Service Bulletin 2023-001 Revision 1

Issue Number: 2023-001

Subject: bar tack/zig zag stitching on main container flap #2

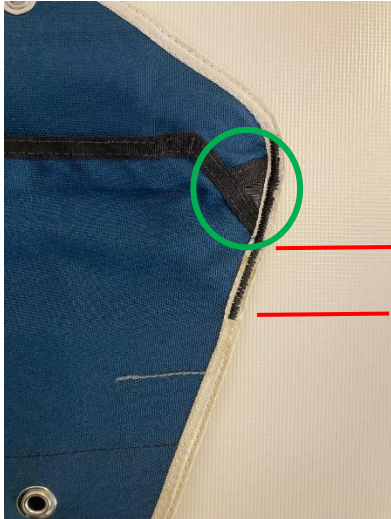
1. Stitching between the two red lines

If the material is weak between the two red lines on the picture below, we recommend strengthening the main container flap #2 with a bar tack/zig zag stitching (minimum 10 stitches per inch, 3mm wide). Start at the end of the binding, where the flap is attached to the reserve container and end at the beginning of the stiffener (red lines in the picture below). You may overstretch your bar tack/zig zag stitching. The result of the stitching is a stiff flap in this area.

2. Stitching between the green circle

The flap #2 is stiff in the area between the two bindings (green circle on the picture above), when your SIFE rig comes out of production because of a stiff material and a stitching under the bindings. If the material and/or the stitching under the bindings are weak after many jumps (green circle in the picture above), overstretch this area also with bar tacks/zick-zack stitching (minimum 10 stitches per inch, 3mm wide).

The result is a stitching, which begins over the first binding and ends at the beginning of the stiffener. The result of the stitching is a stiff flap in this area.

You don't have to separate the flap from the reserve container while doing the bar tacks/zig zag stitching.

Check the stitching and the material of the flap #2 (between red lines and green circle) on each reserve repack.

If the flap #2 stays weak between the red lines and/or the green circle after your stitching, we recommend contacting SIFE and ordering a new center flap. See prices on www.sife.at
